## PETITION, LOCAL MEMBER OBJECTION

APPLICATION No. **19/00016/MJR**

LOCATION: 637 Cowbridge Road East, Canton, Cardiff, CF5 1BH

PROPOSAL: DEMOLITION OF EXISTING CAR SHOWROOM BUILDING, RELOCATION OF EXISTING ACCESSES, ERECTION OF FOUR/FIVE STOREY BUILDING TO COMPRISE PARKING AT GROUND FLOOR LEVEL AND 23NO. ONE AND TWO BEDROOM AFFORDABLE HOUSING APARTMENTS AT 1ST, 2ND, 3RD AND 4TH FLOOR, LANDSCAPING AND ANCILLARY WORKS

Job No	Sheet No	Revision
4355	A-00-100	B

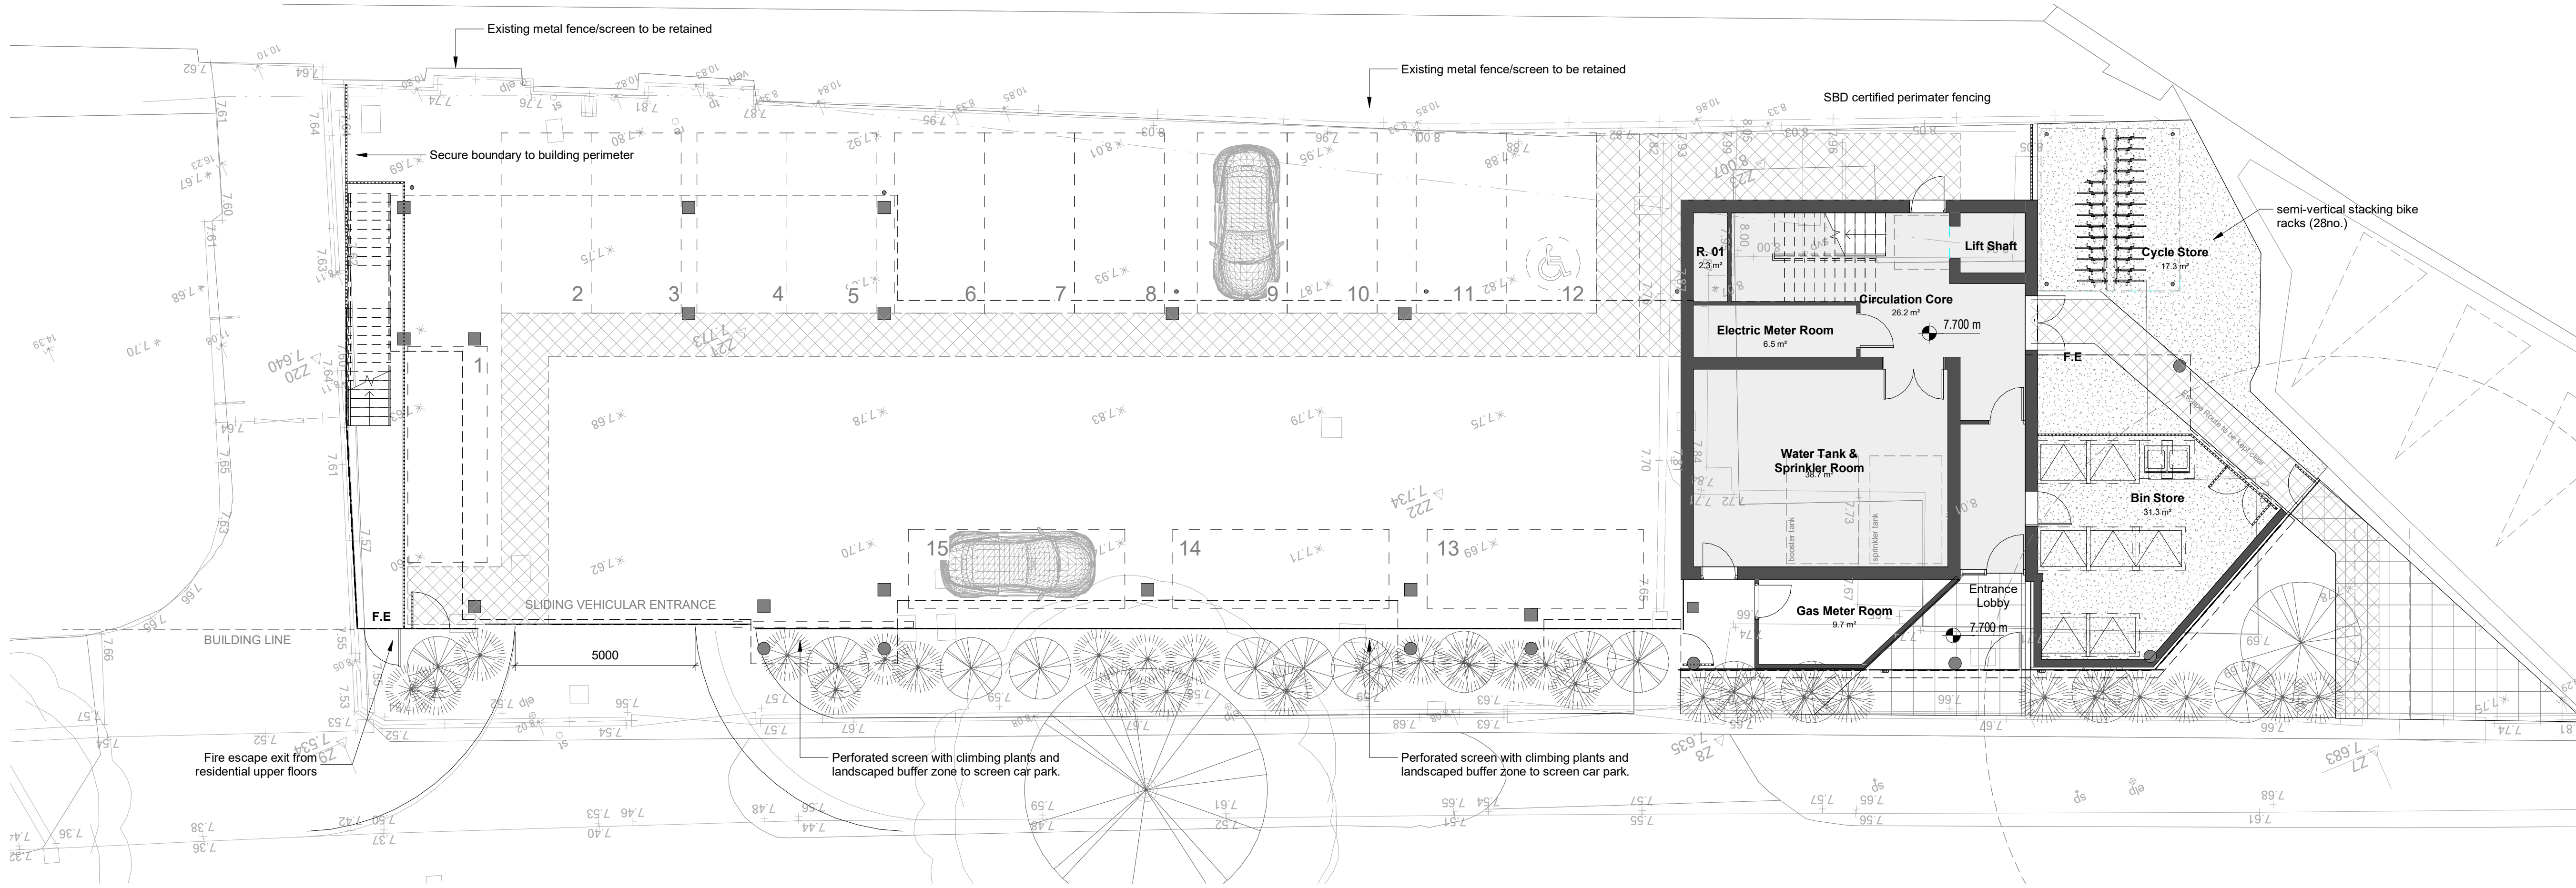
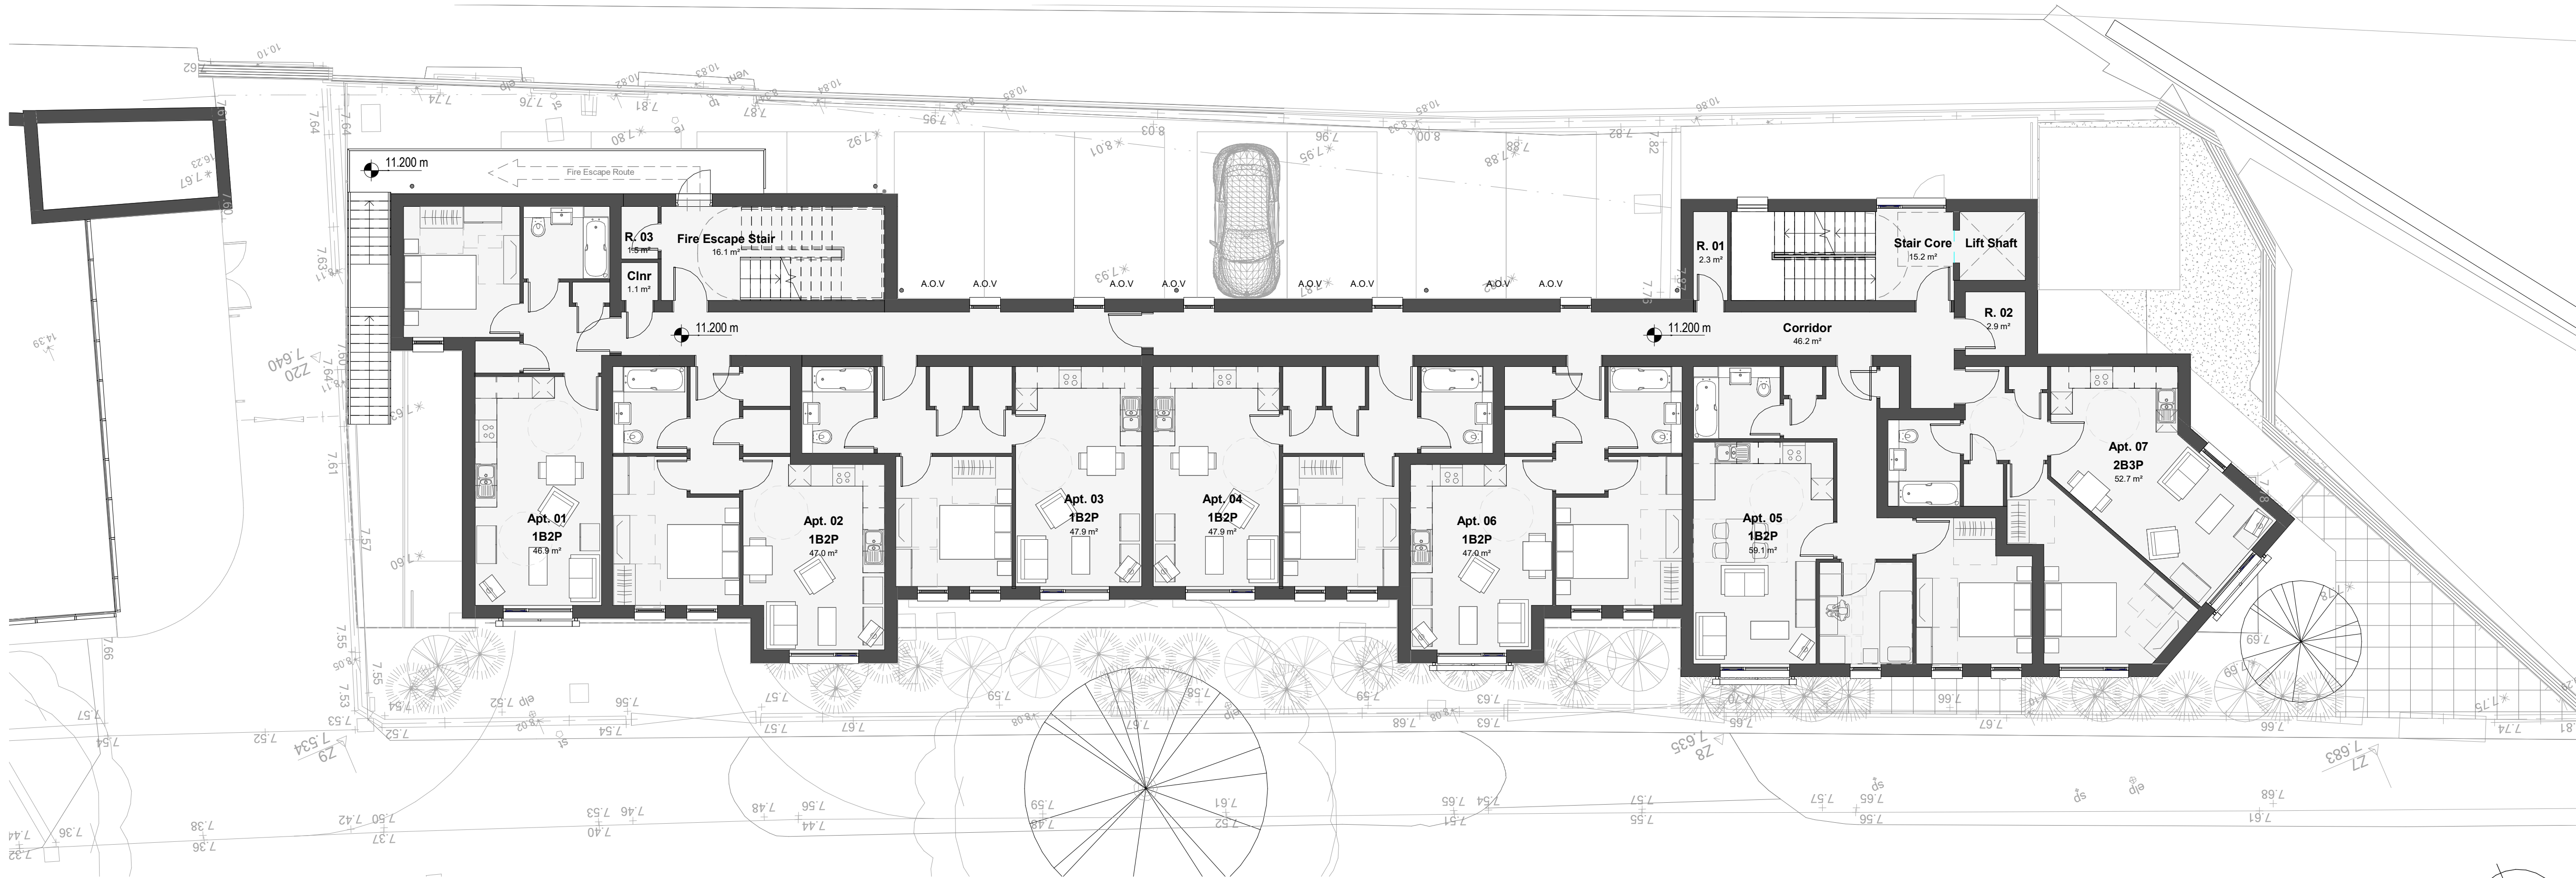
B	25.04.19	RC	Undercroft Car park ownership revised to residential. Associated access to Royal Mail omitted, new access into building core added.
A	30.01.19		Proposals revised to provide area reduction to apartments.
-	21/12/18	RC	FIRST ISSUE
Rev	Date	Check	Description
